From: Wagner, David B (PDS)
Sent: Wednesday, August 19, 2015 3:50 PM
To: 'Grace Bryan'
Subject: RE: Land Development Meeting on 7/23 15Zone1015

PUBLIC HEARING
**ZONING
CHANGE**
RR to R5A
CASE #15Z0NE1015
DATE: AUGUST 20, 2015
THURSDAY 1:00 PM
514 WEST LIBERTY STREET
OLD JAIL BUILDING
THIS PROPOSAL MAY BE REVIEWED
AT PLANNING & DEVELOPMENT
DEPARTMENT OFFICE CENTER
440 S. 10th STREET, 12th FLOOR
HOUSTON, TX 77001 **574-6230**

April 2015 picture of 10509

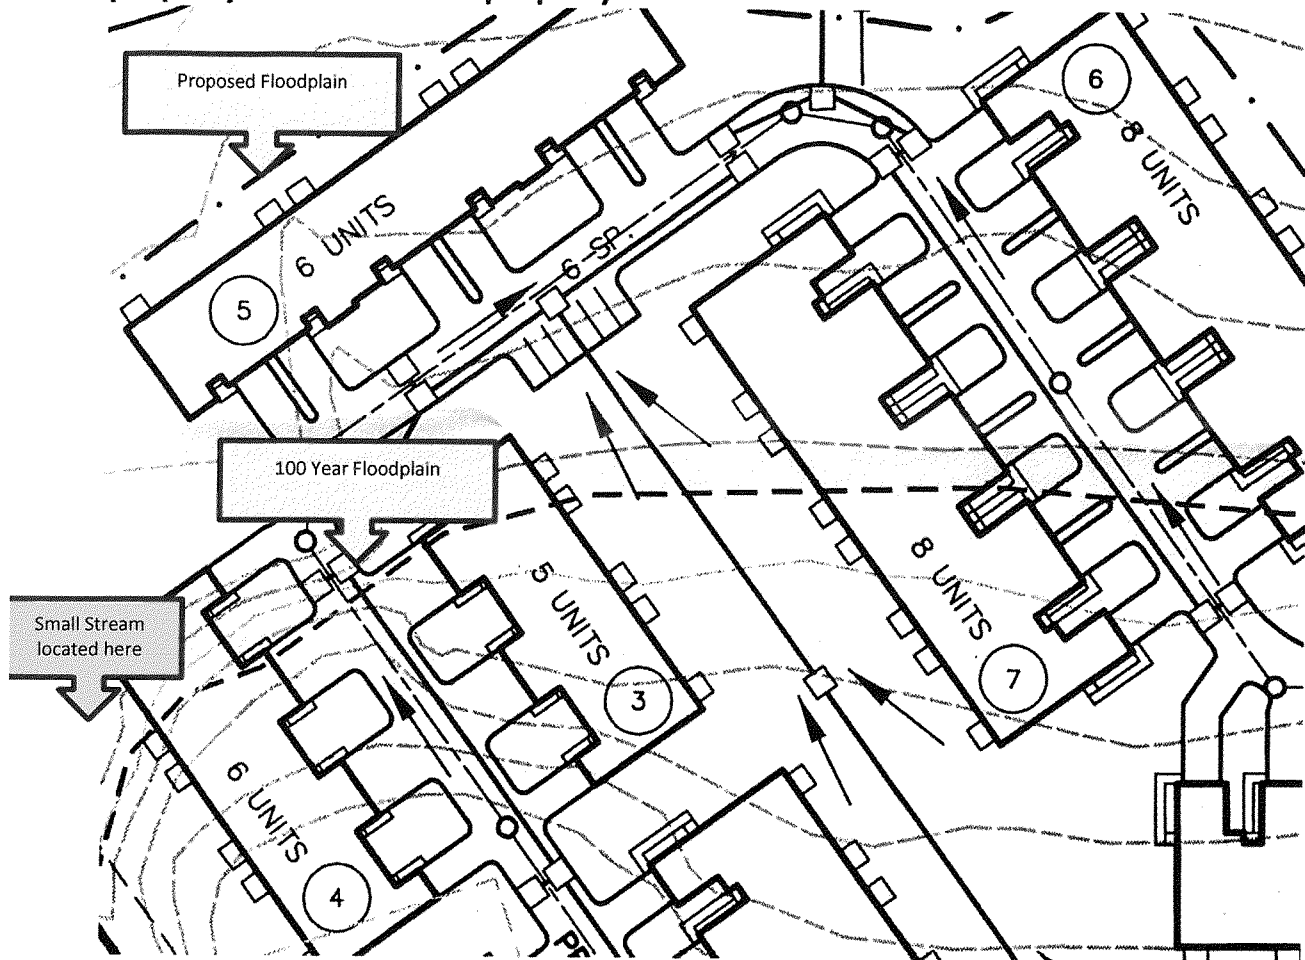
#3, 4, 5, 6 and 7 buildings, 33 Apartments to be built in flood area. Flooding has occurred in 1997, 2009, 2011, 2013, and 2015. Flooding is more frequent as subdivisions are built closer to the Floyds Fork. Yellow note displays location of the small stream running from the 10505 property onto the 10509 property.

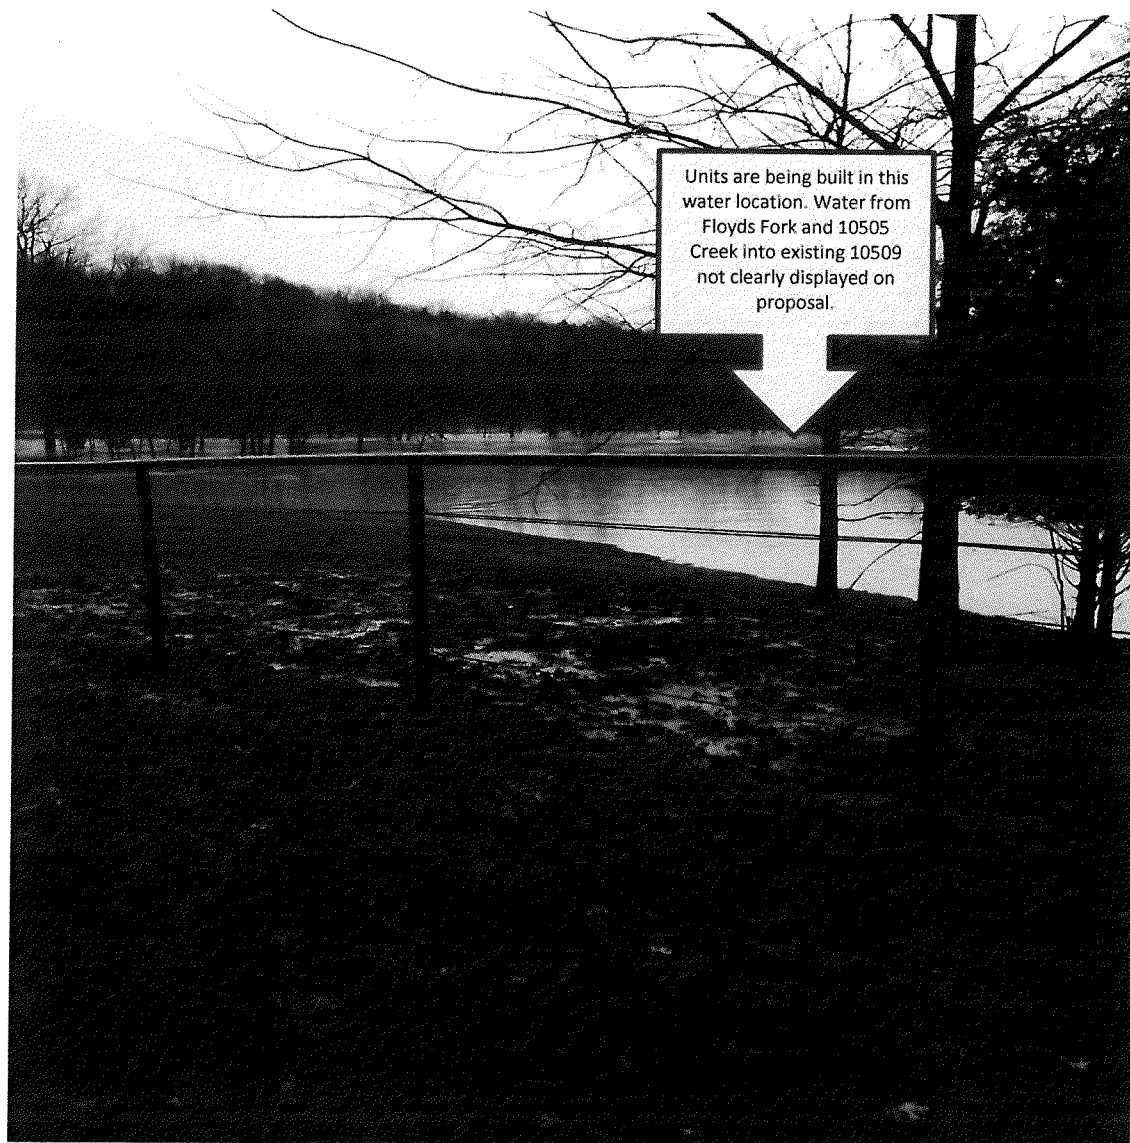
Below is an April 2015 picture of the small stream (not so small during flooding) on the 10509 property.

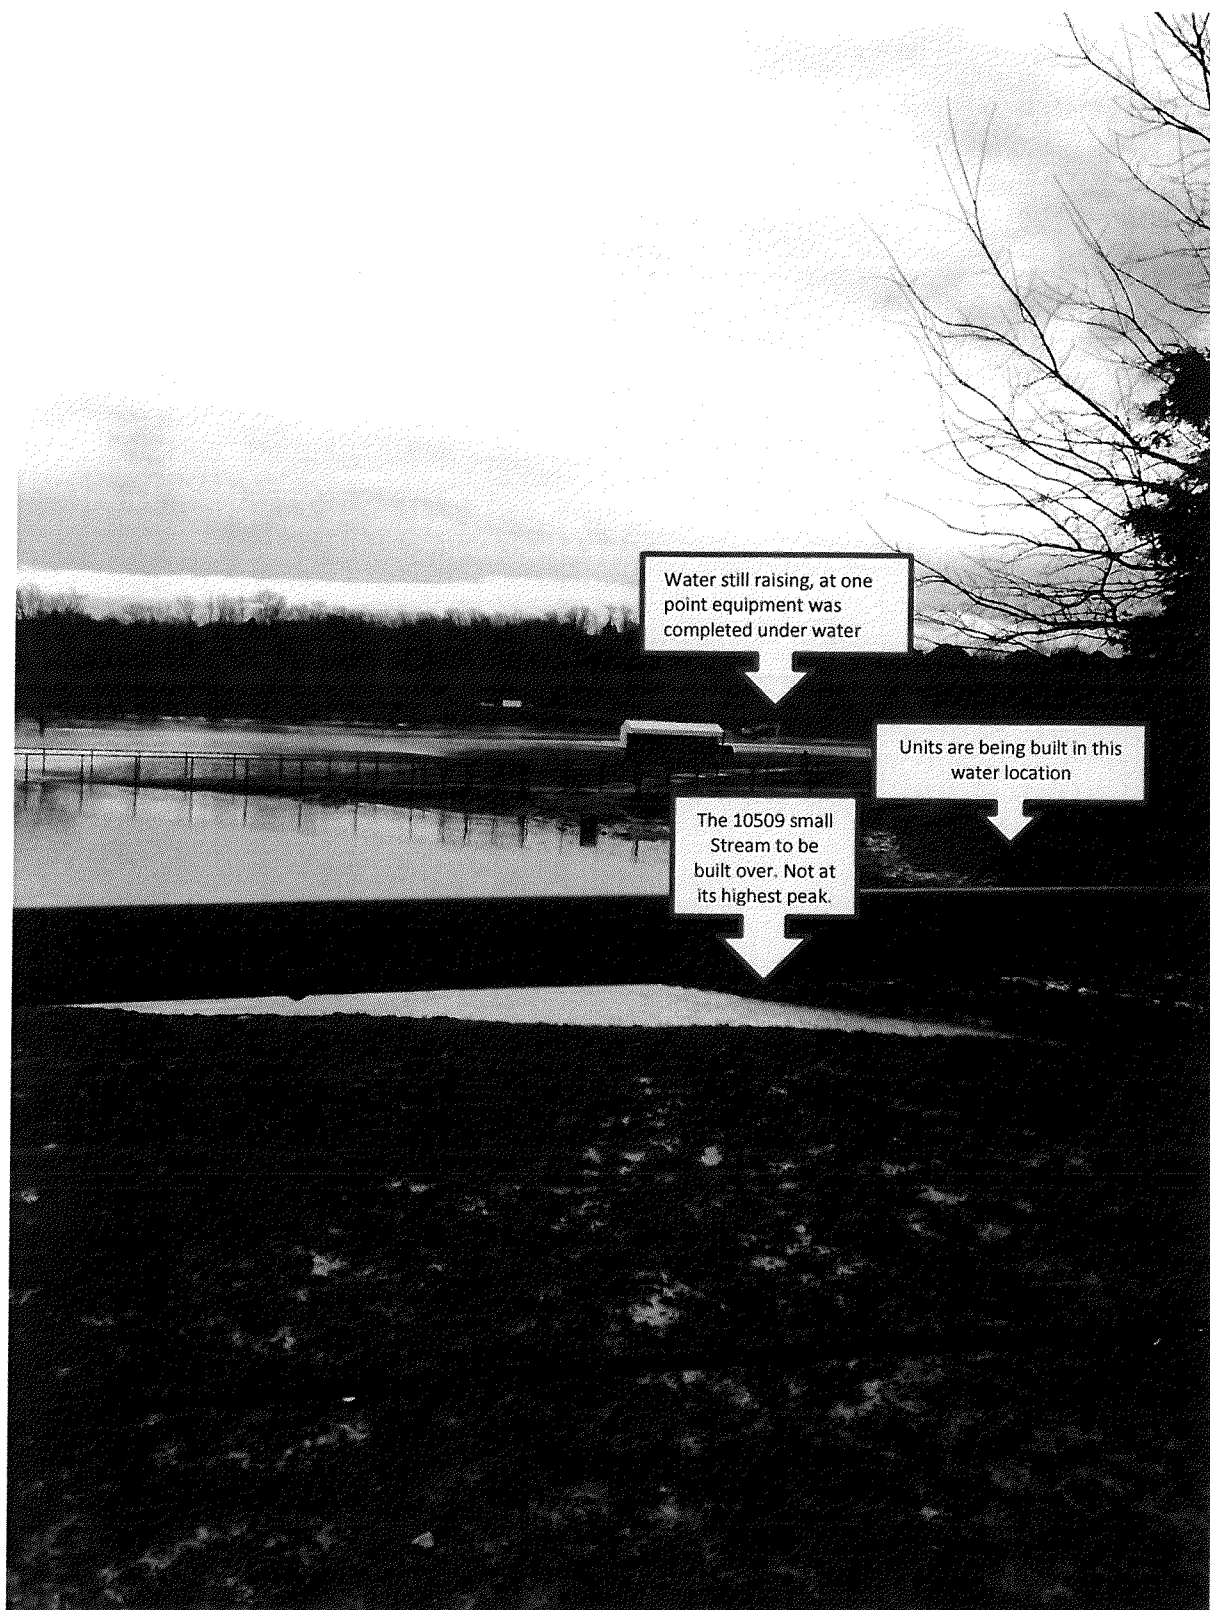
Below April 2015 picture is of the small stream on the 10509 property. The Parkland Bridge is in the background.

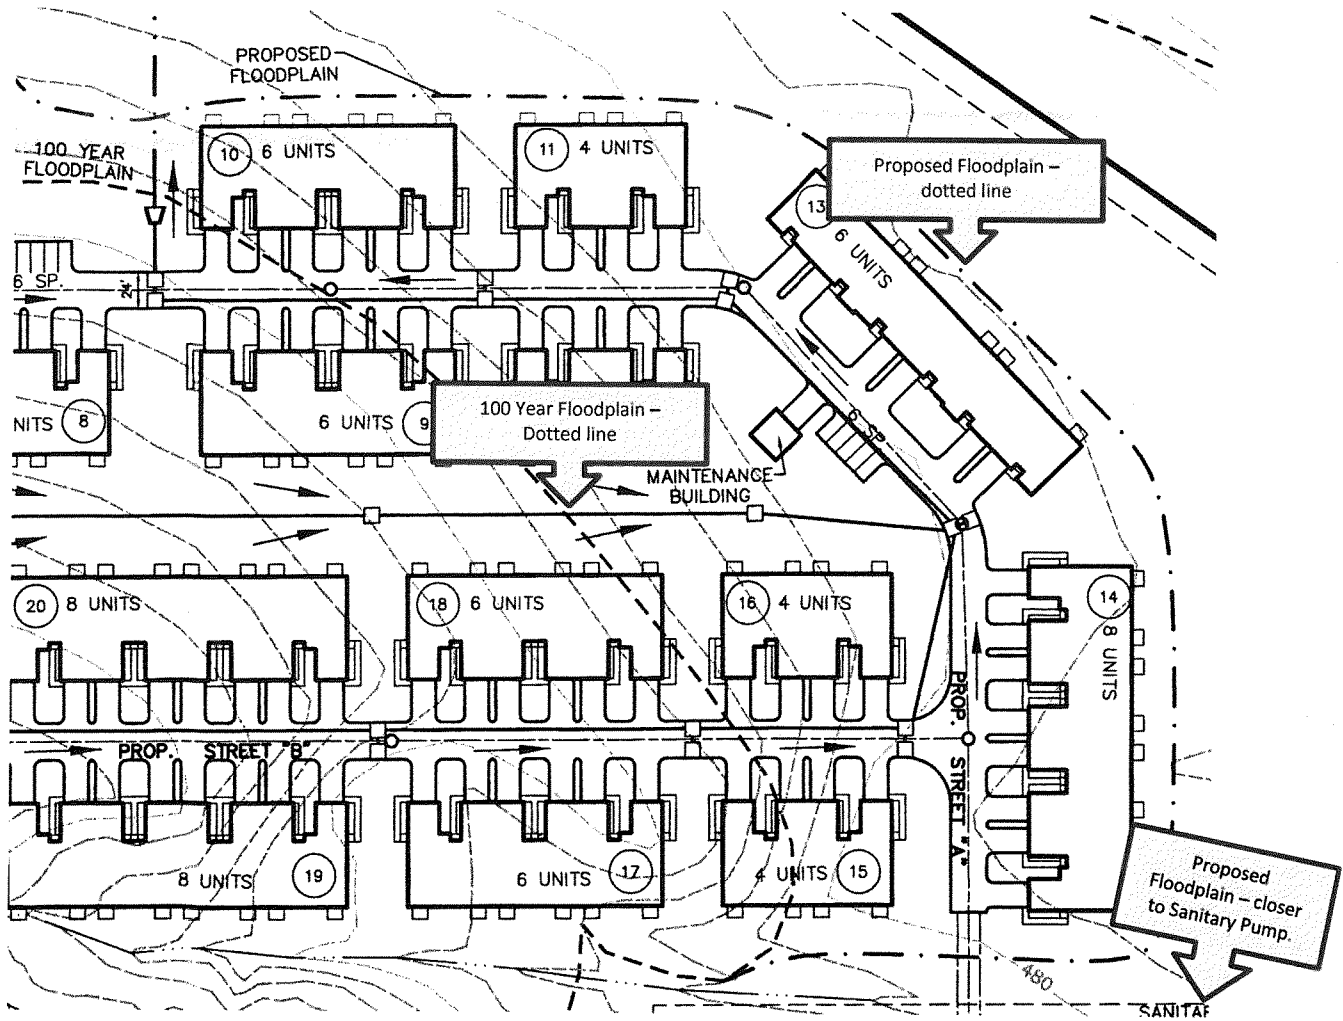
Large distance between the 100 Year Floodplain to the Proposed Floodplain. For approximately the last 20 years every 5 years the property has been flood past the 100 Year Floodplain.

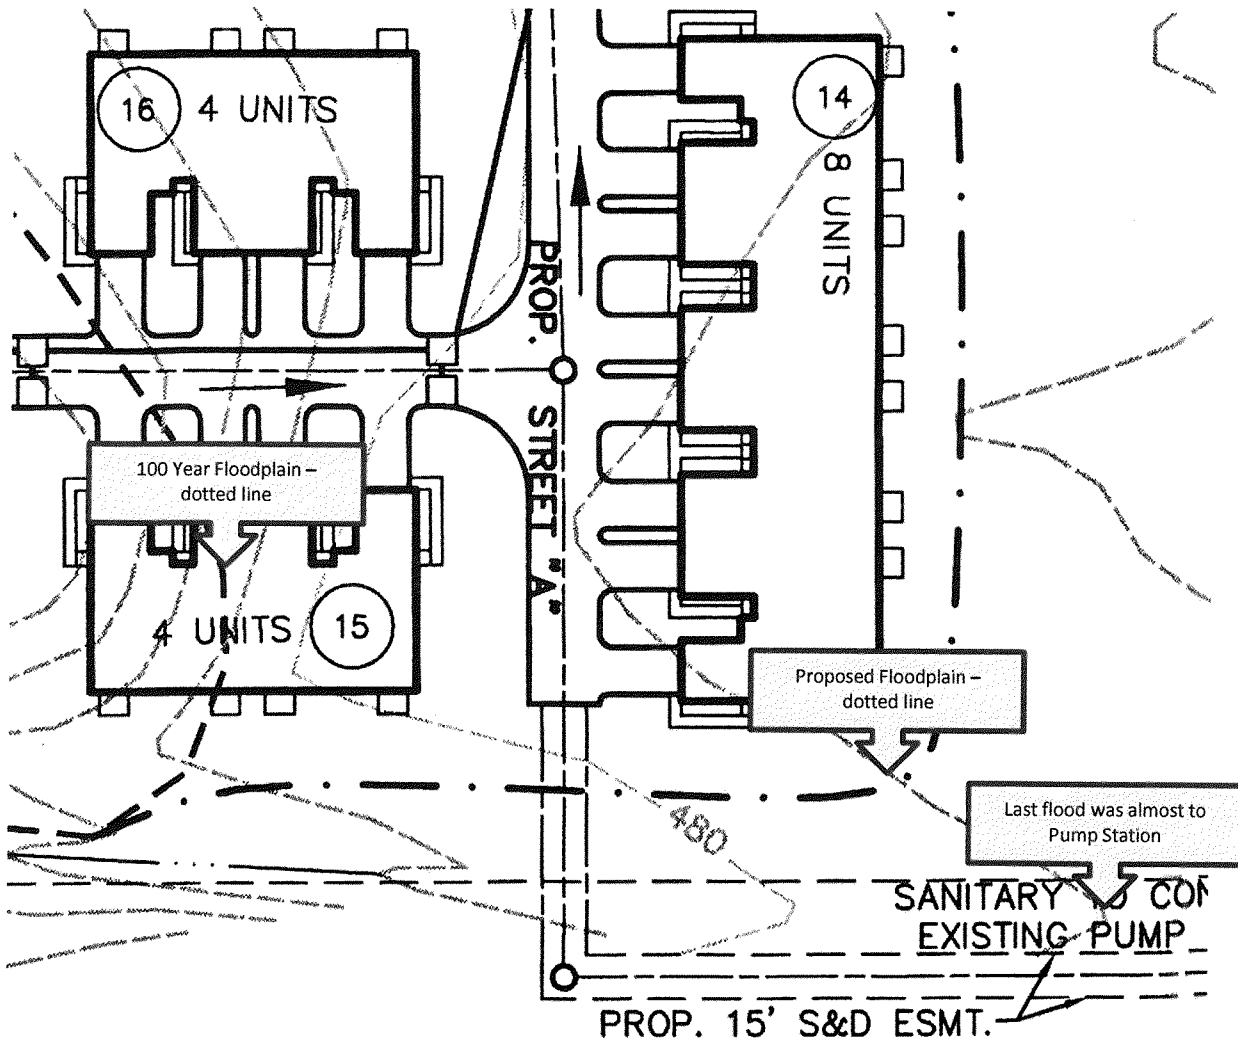
Proposed Floodplain is closer to the Sanitary Pump Station than the 100 Floodplain. 2015 Flood came dangerously close to the Pump Station, now they are proposing a closer Floodplain.

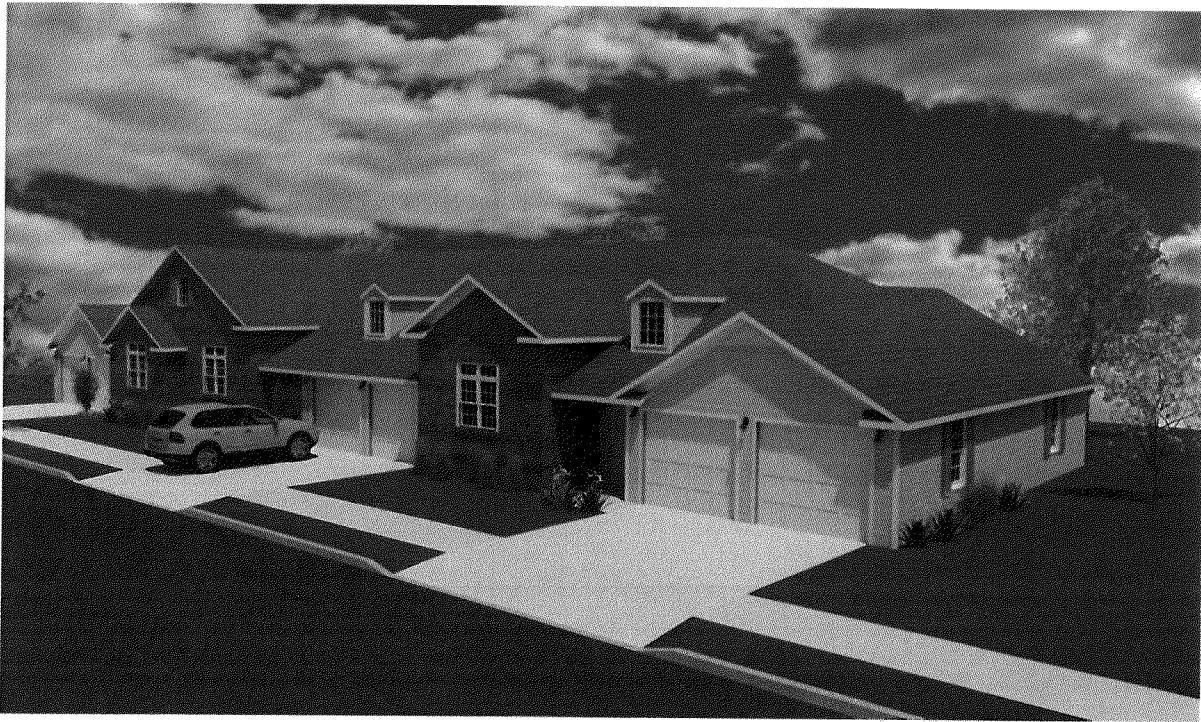
Example of what will be built – backside is not shown in any of the pictures. The backside will NOT be brick. If plans are approved requesting Brick to keep with the character of other units within the area and to be more appealing to the eye as well as being able to stand up to flooding.

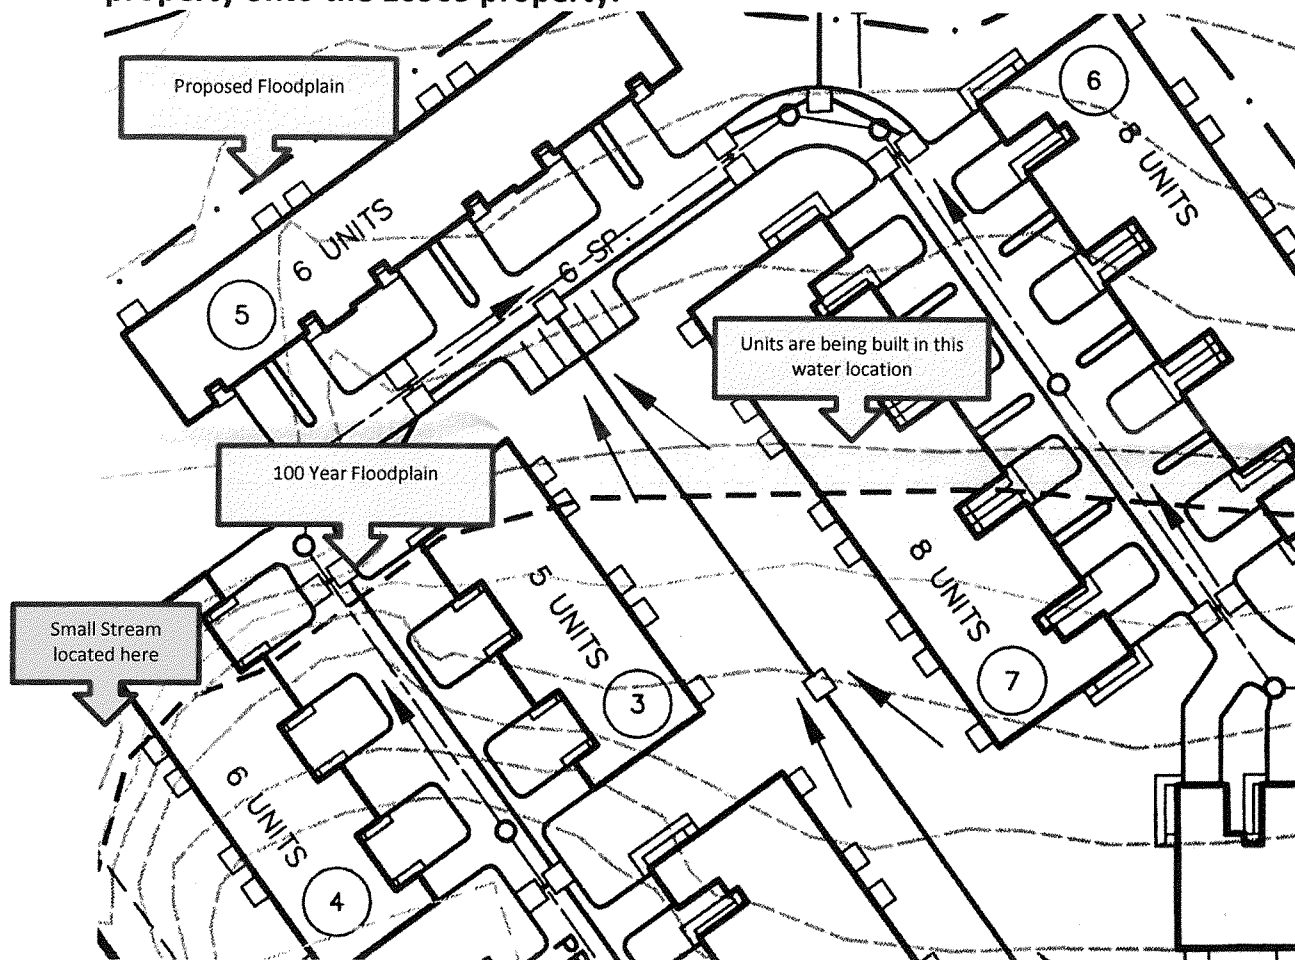
#3, 4, 5, 6 and 7 buildings, 33 Apartments to be built in flood area. Flooding has occurred in 1997, 2009, 2011, 2013, and 2015. Flooding is more frequent as subdivisions are built closer to the Floyds Fork. Yellow note displays location of the small stream running from the 10505 property onto the 10509 property.

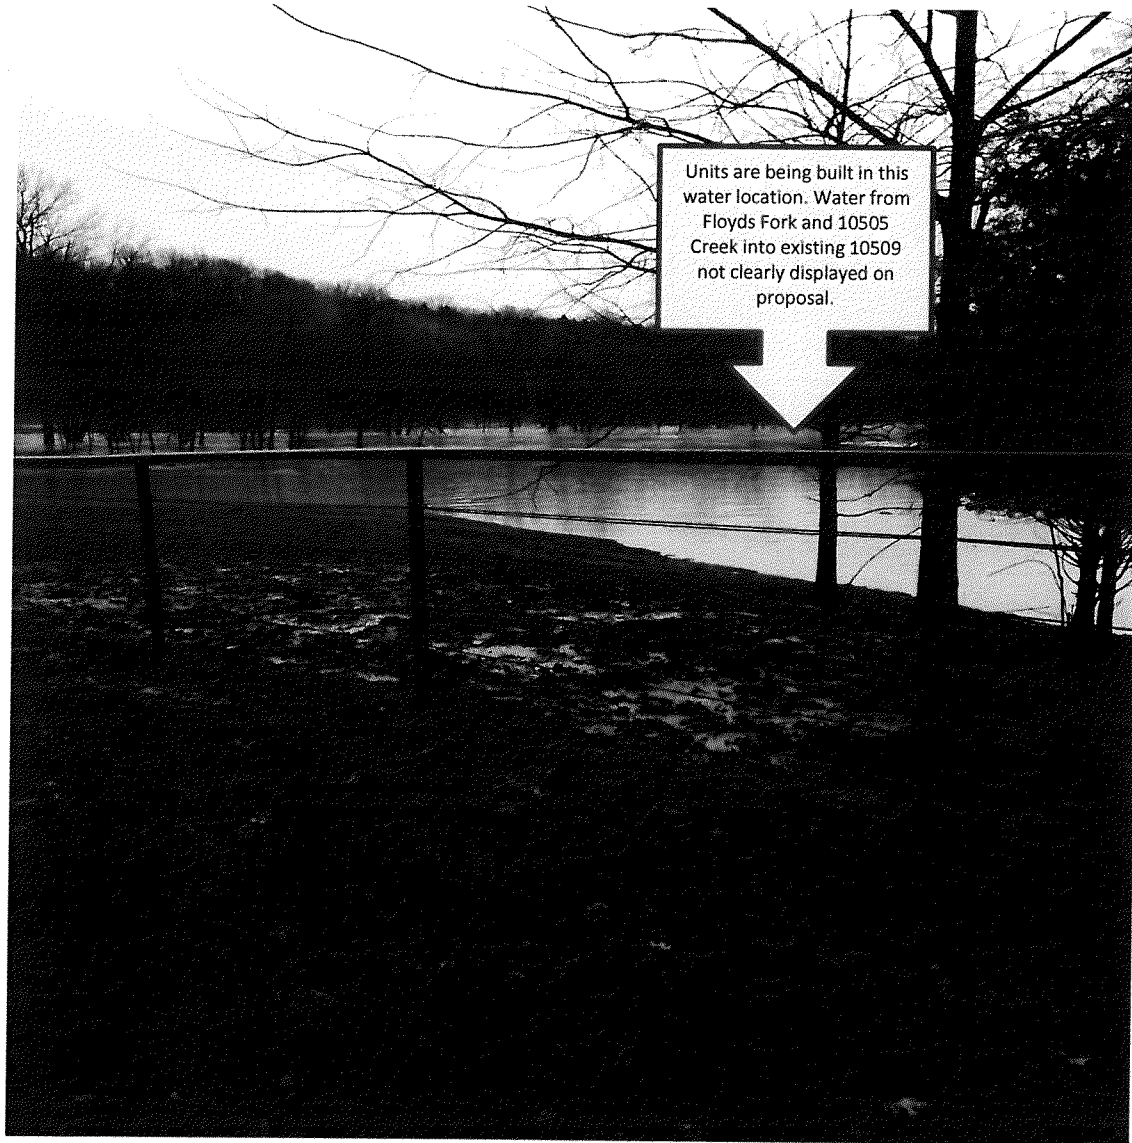
Below is an April 2015 picture of the small stream (not so small during flooding) on the 10509 property.
